ADDENDUM NO.: 4

DATE OF ADDENDUM: August 21, 2015

**CAMPUS RENOVATIONS
ASNUNTUCK COMMUNITY COLLEGE
170 ELM STREET
ENFIELD, CT
BI – CTC-437**

ROOF FRAMING PLAN
 1/8" = 1'-0"

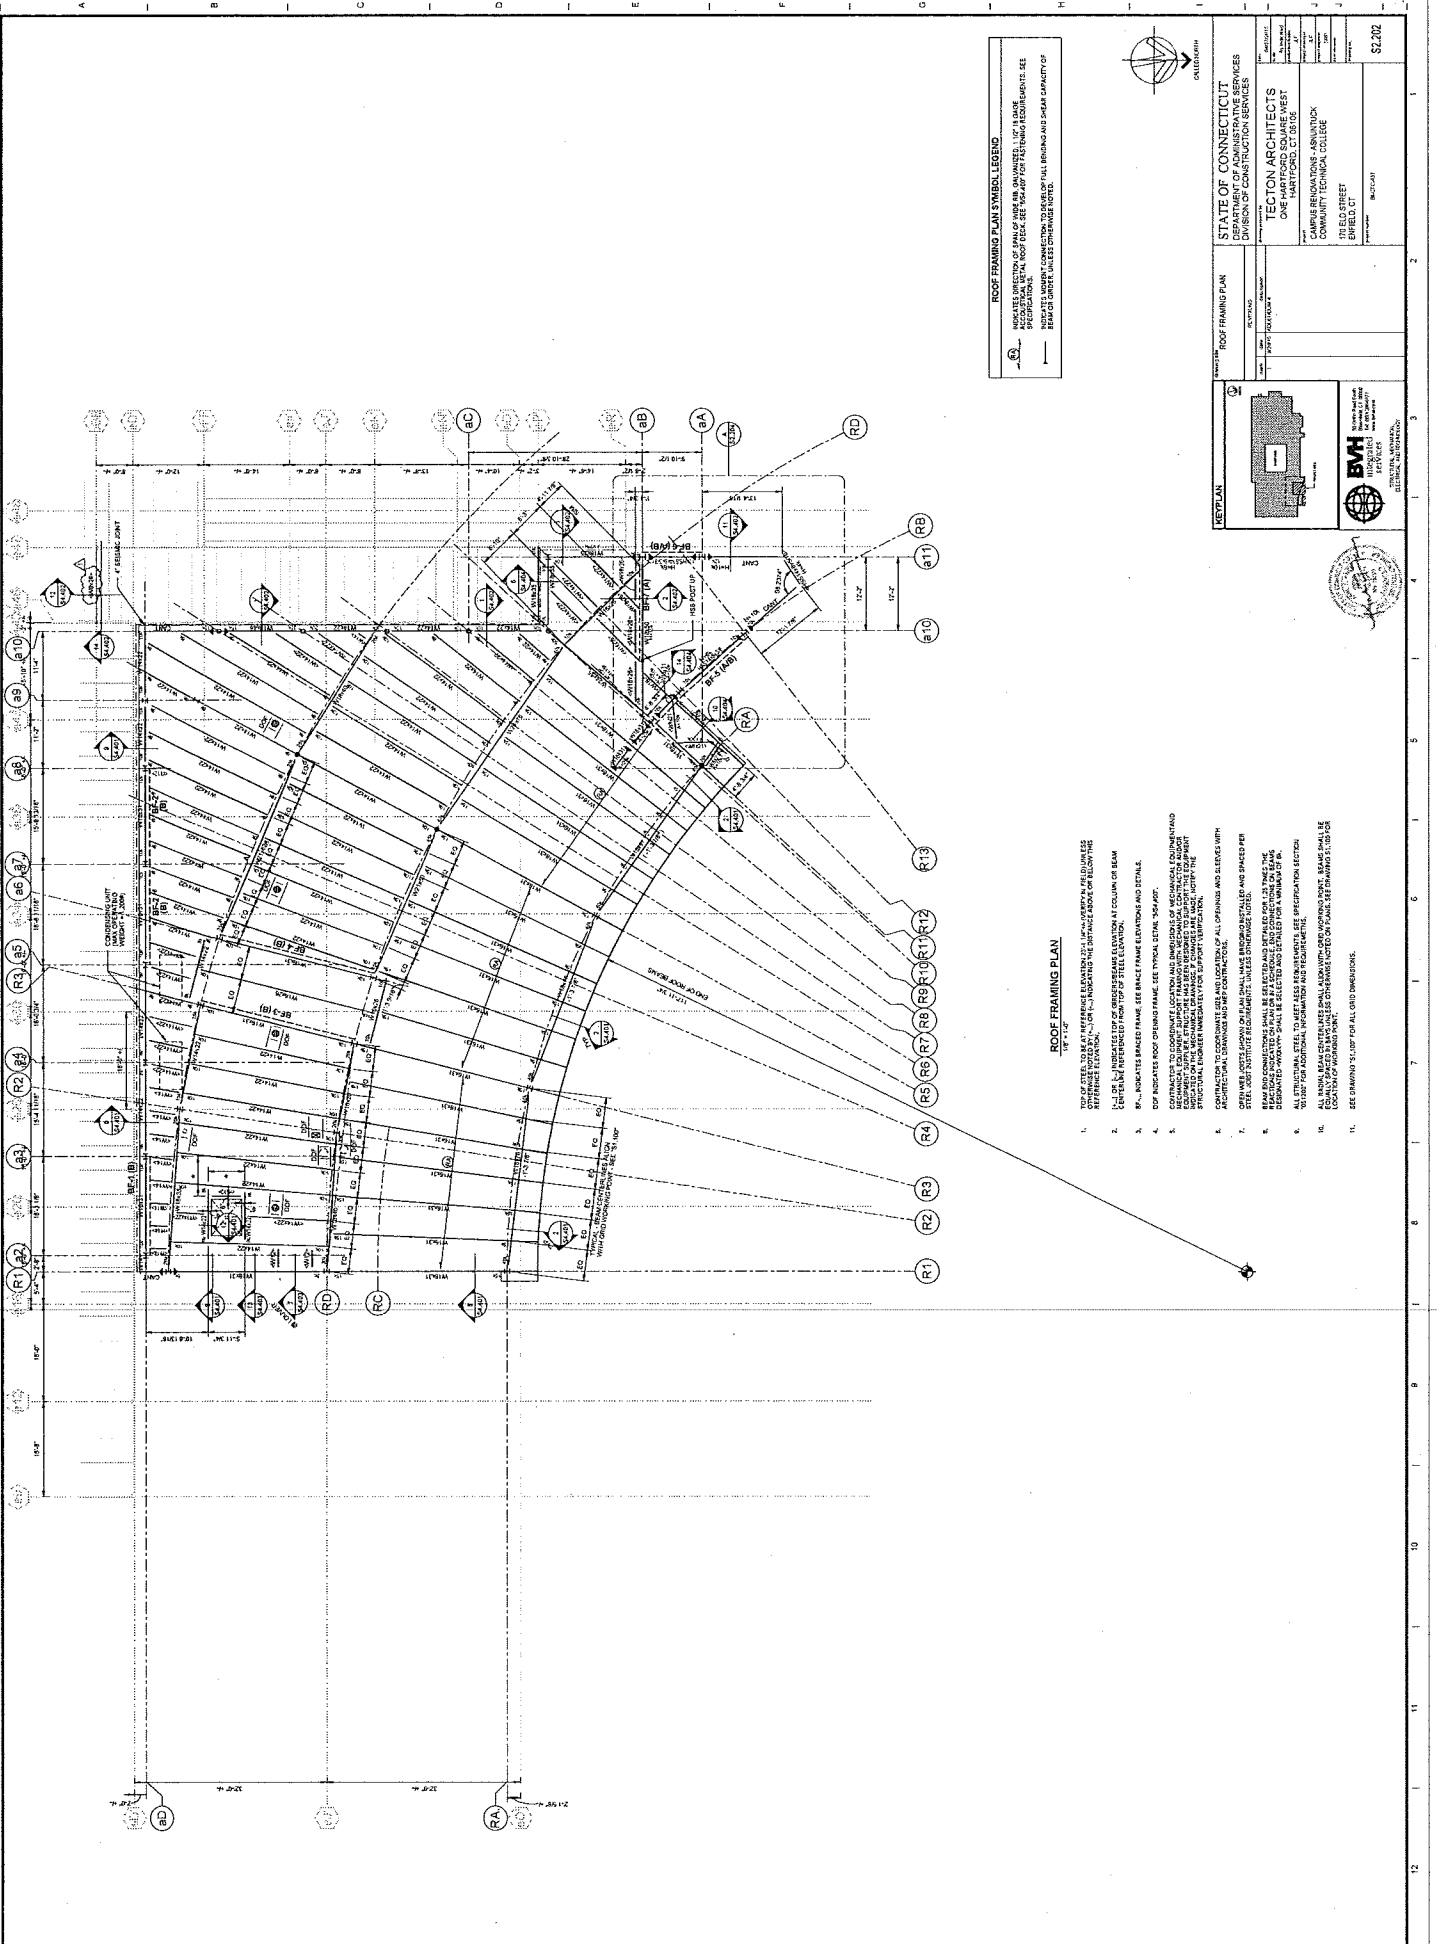
- REVISED beam size as indicated.

Drawing A1.103 - First Floor Reflected Ceiling Demolition Plan

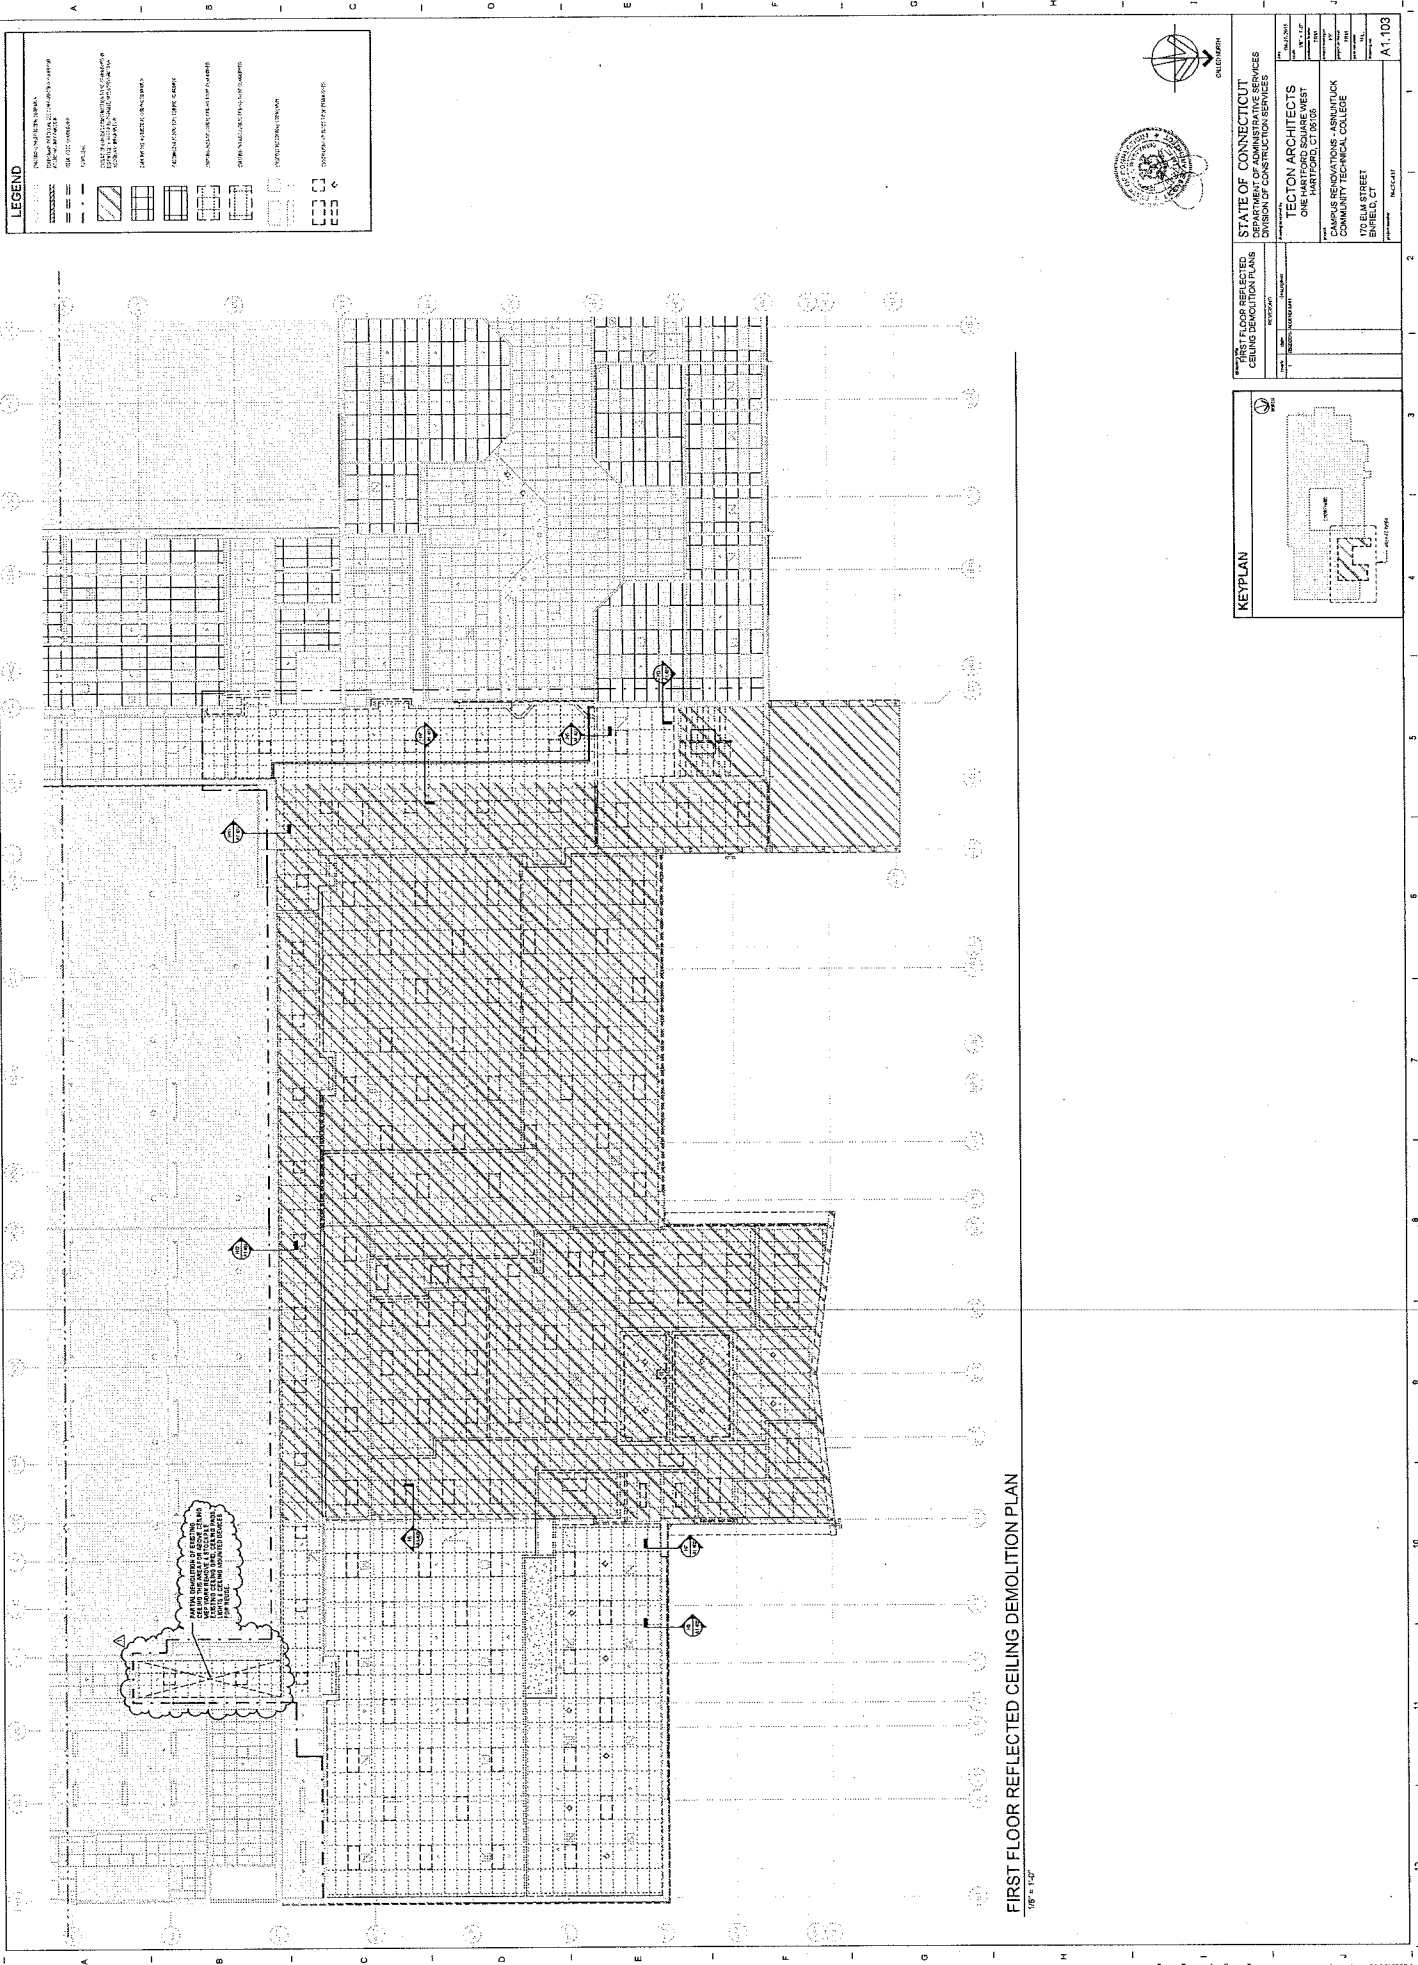
- **ADDED** demolition of existing ceiling in Corridor #e25 added to scope for installation and reconfiguration of above ceiling MEP items in this area.

FIRST FLOOR FINISH PLAN
1/8" = 1'-0"

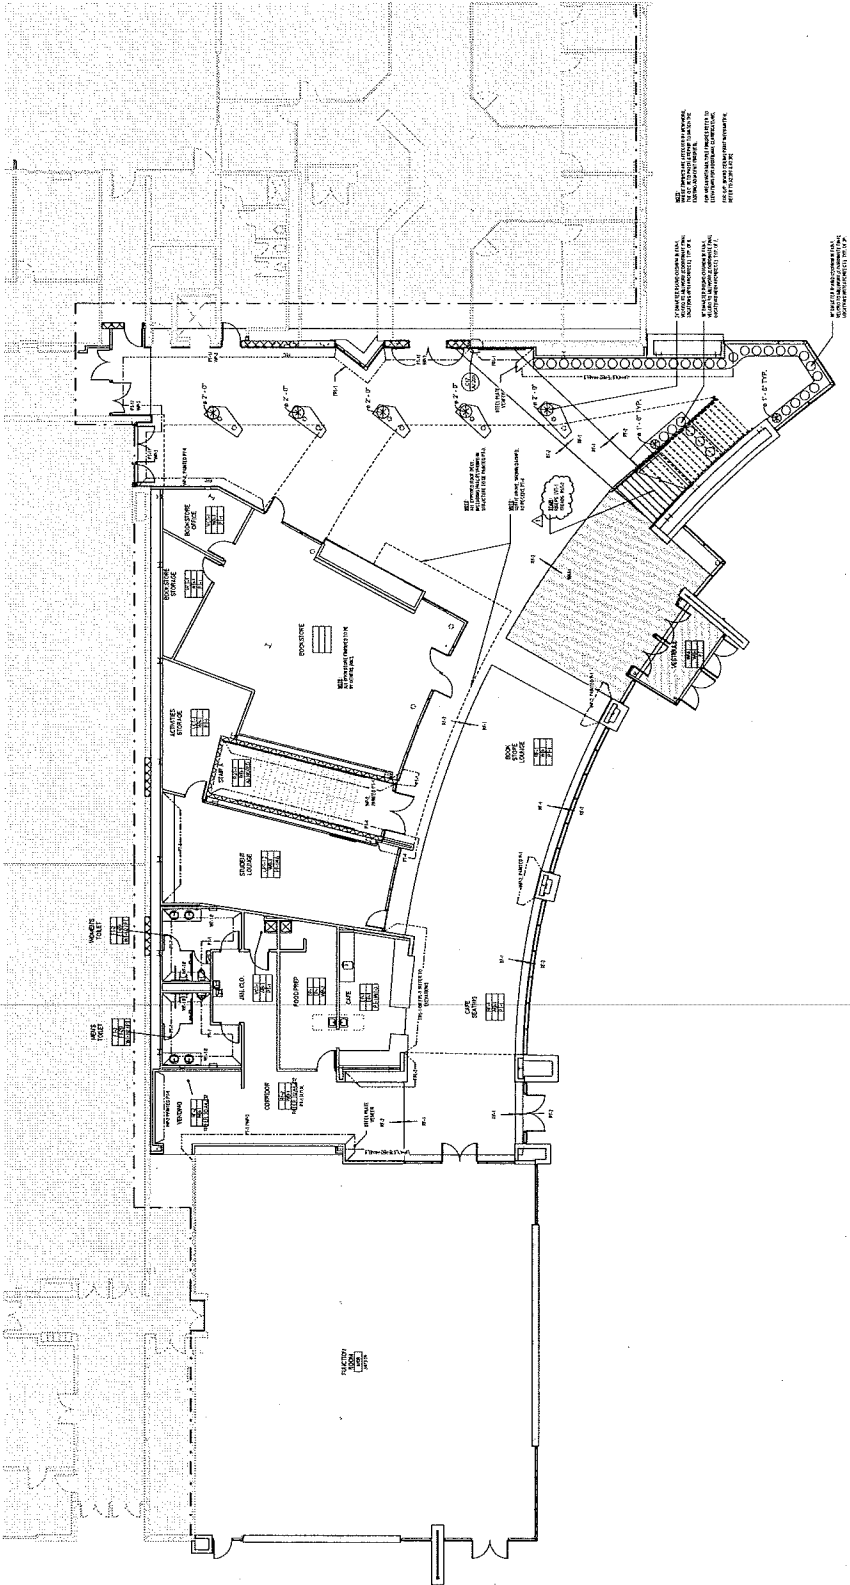
- **REVISED** communicating stair tread and riser finishes.

412 ROOF PLAN - OVERALL REFERENCE PLAN
1/8" = 1'-0"

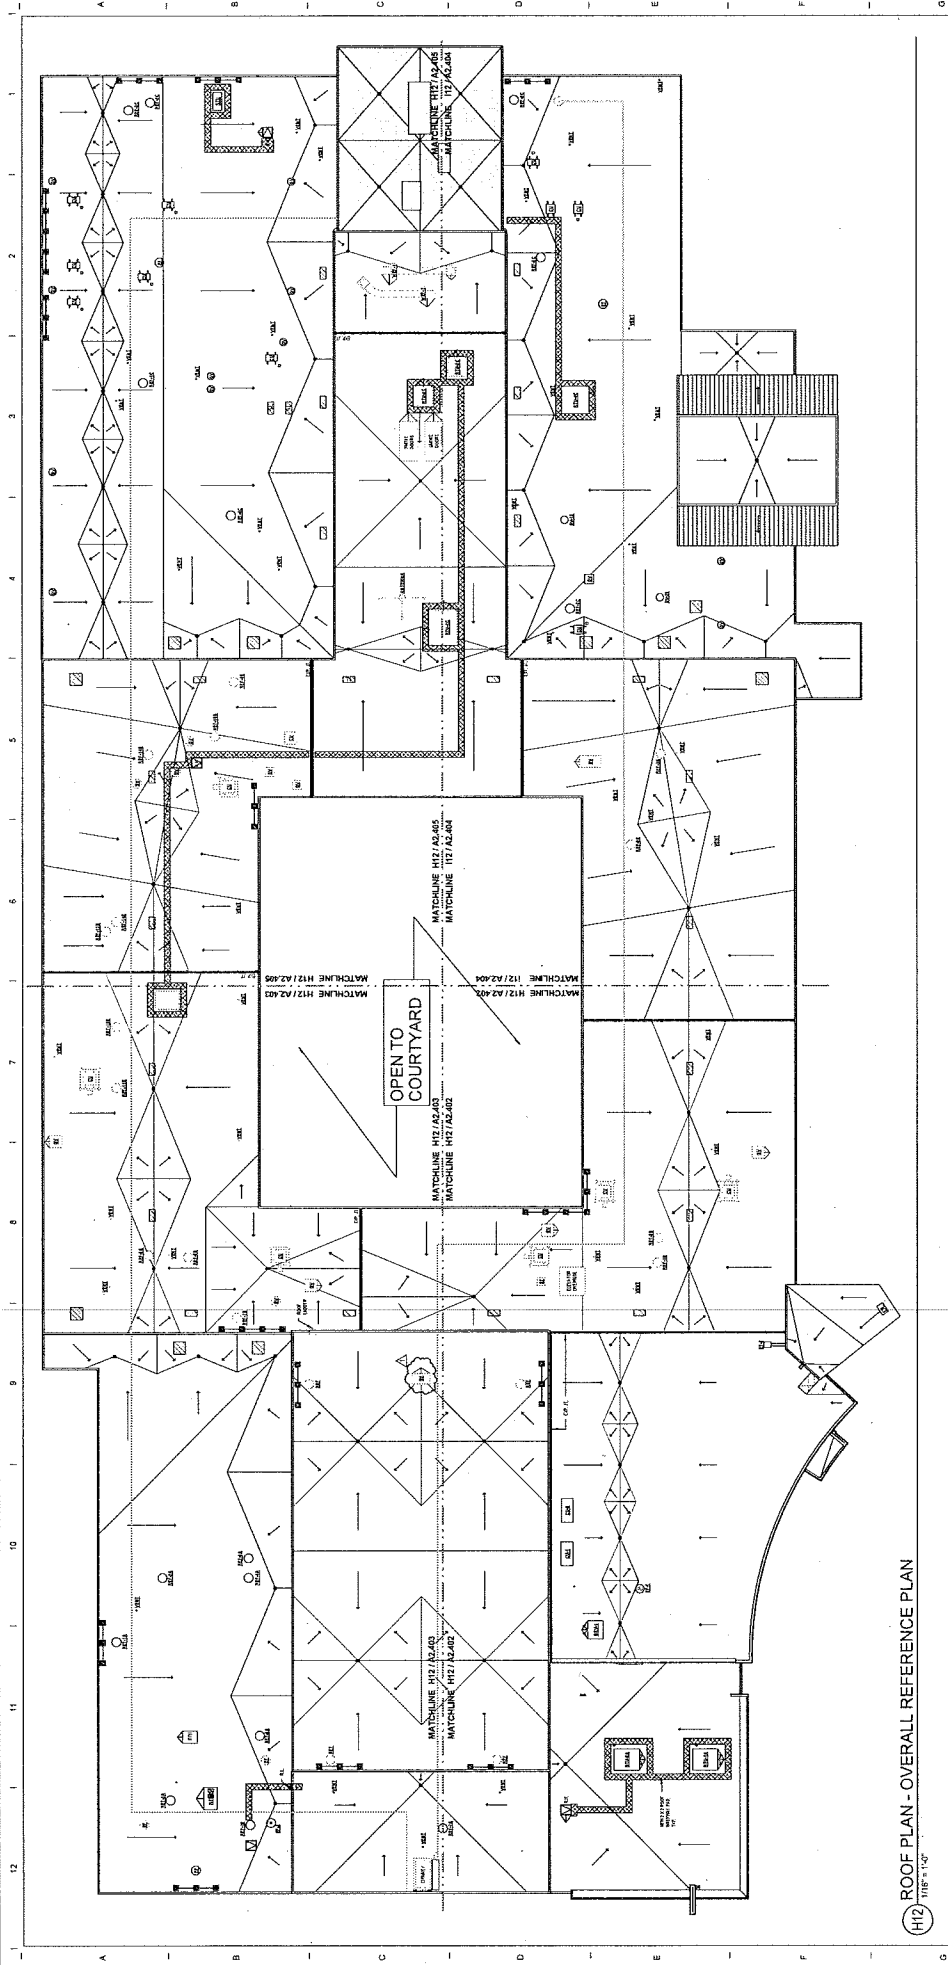
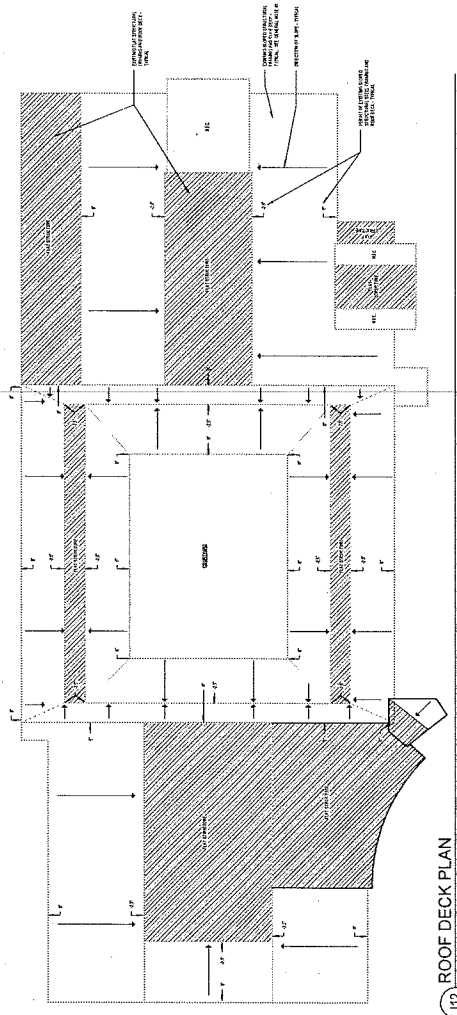
- **ADDED** Existing roof top equipment to gym roof on plan H12

H12 PARTIAL ROOF PLAN - NORTHEAST
 REF: 1-10

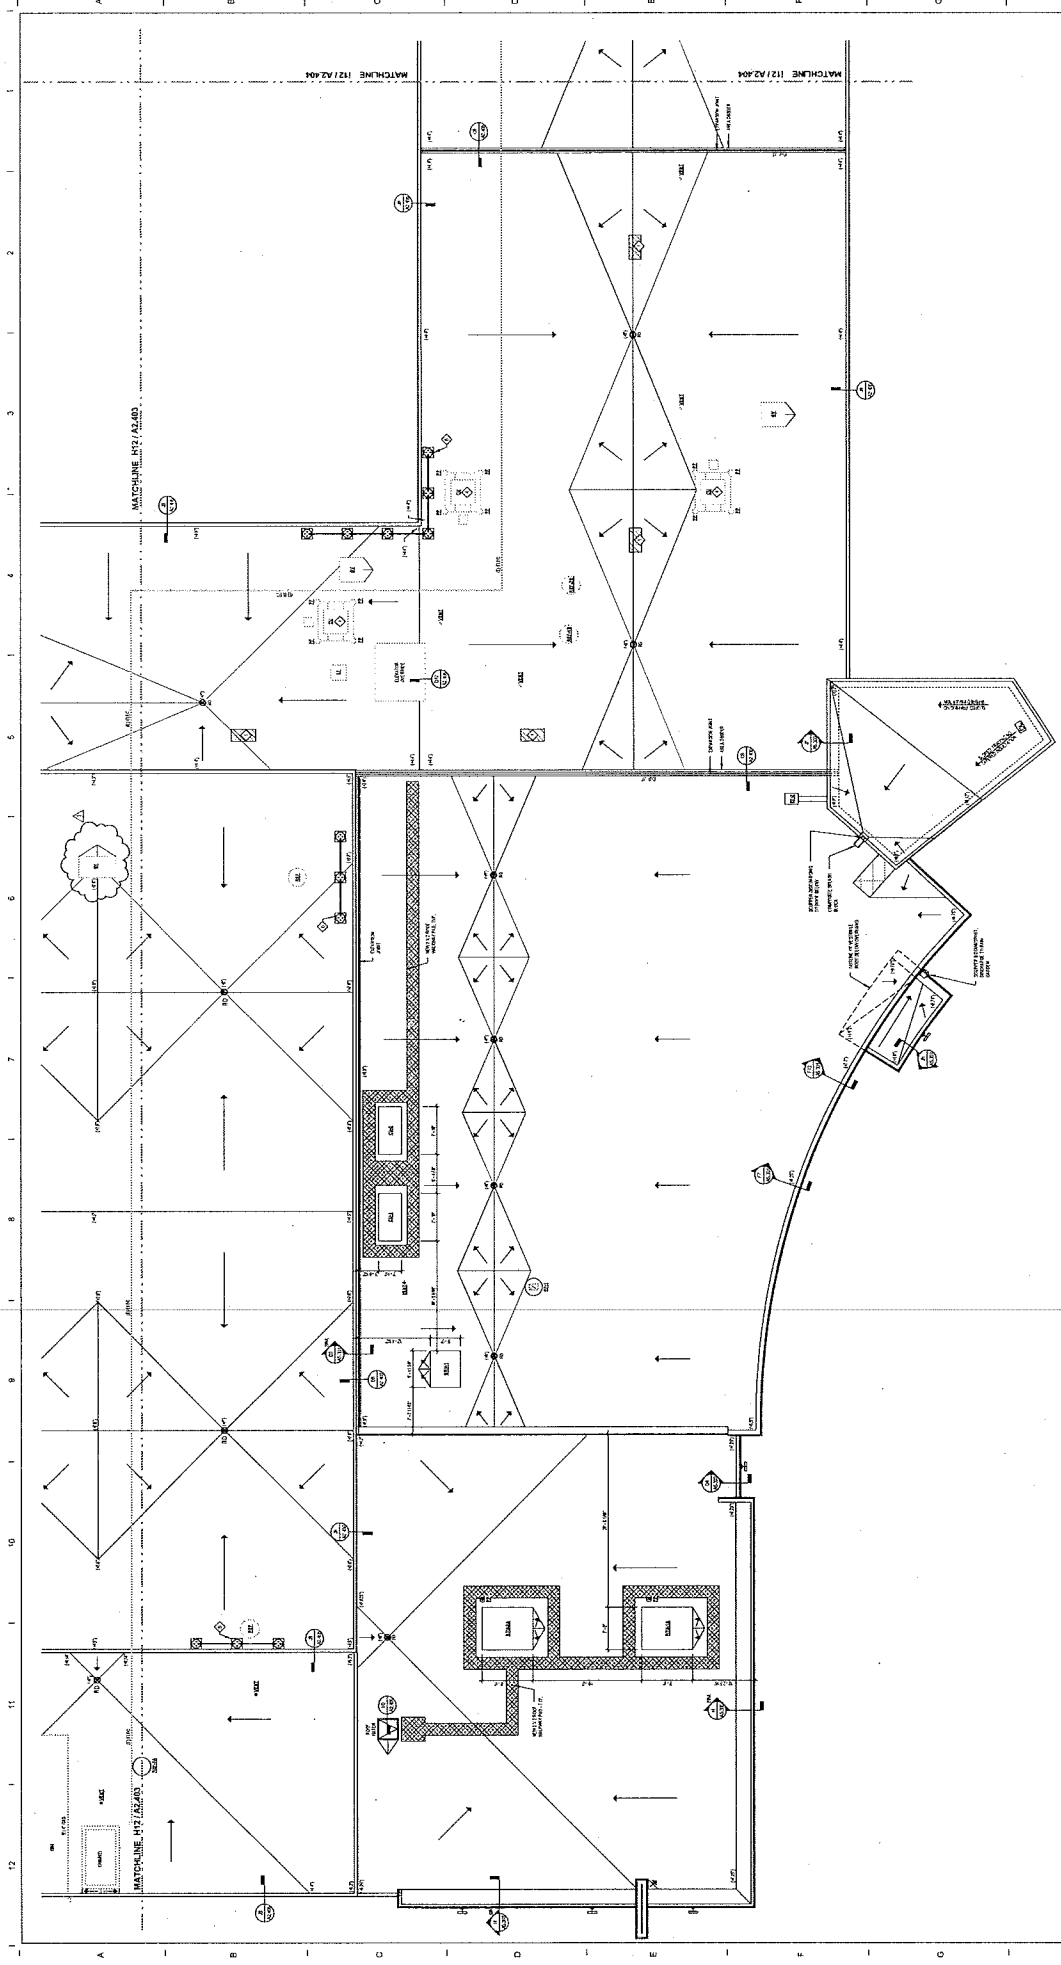
- **ADDED** Existing roof top equipment to gym roof
